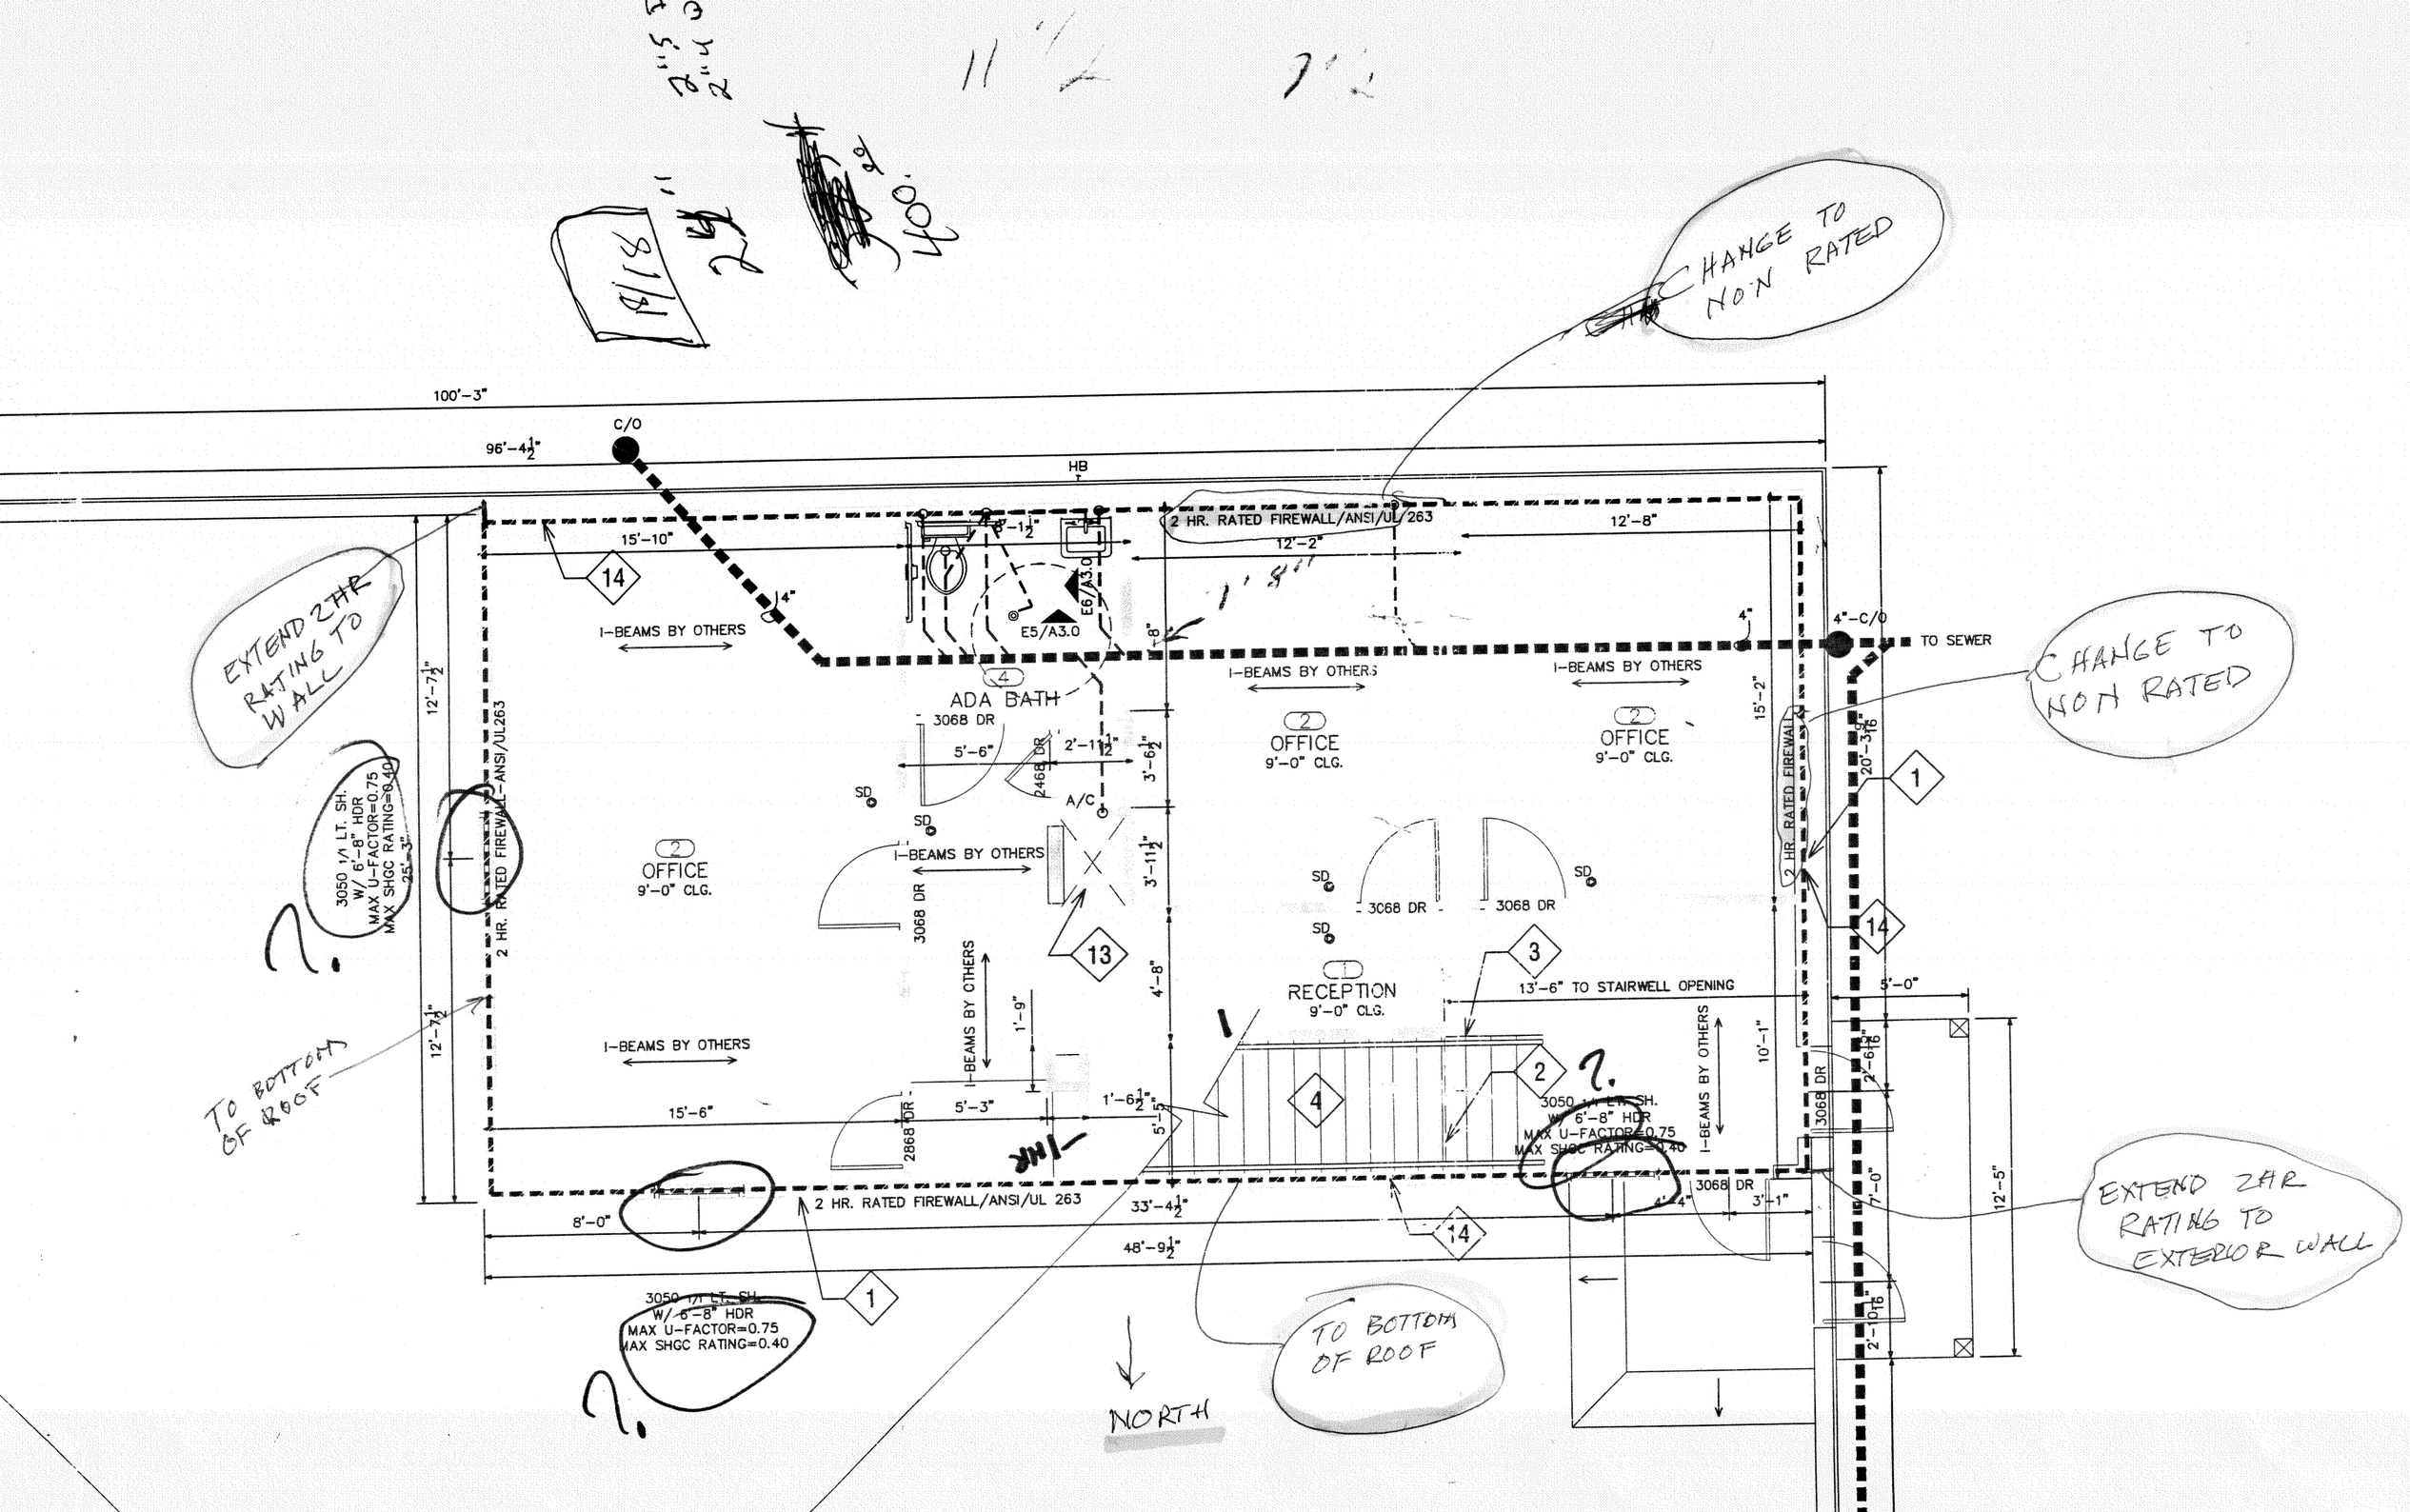
100'-3"
96'-4½"
C/O
HB
2 HR. RATED FIREWALL/ANSI/UL 263
CHANGE TO NON RATED
EXTEND 2HR RATING TO WALL
15'-10"
14
I-BEAMS BY OTHERS
E5/A3.0
E6/A3.0
ADA BATH
3068 DR
OFFICE
9'-0" CLG.
12'-8"
12'-2"
4"-C/O
TO SEWER
CHANGE TO NON RATED
1
3050 1/1 LT. SH. W/ 6'-8" HDR MAX U-FACTOR=0.75 MAX SHGC RATING=0.40
12'-7½"
2 HR. RATED FIREWALL-ANSI/UL263
A/C
SD
RECEPTION
9'-0" CLG.
13'-6" TO STAIRWELL OPENING
TO BOTTOM OF ROOF
15'-6"
8'-0"
33'-4½"
48'-9½"
2 HR. RATED FIREWALL/ANSI/UL 263
EXTEND 2HR RATING TO EXTERIOR WALL
NORTH
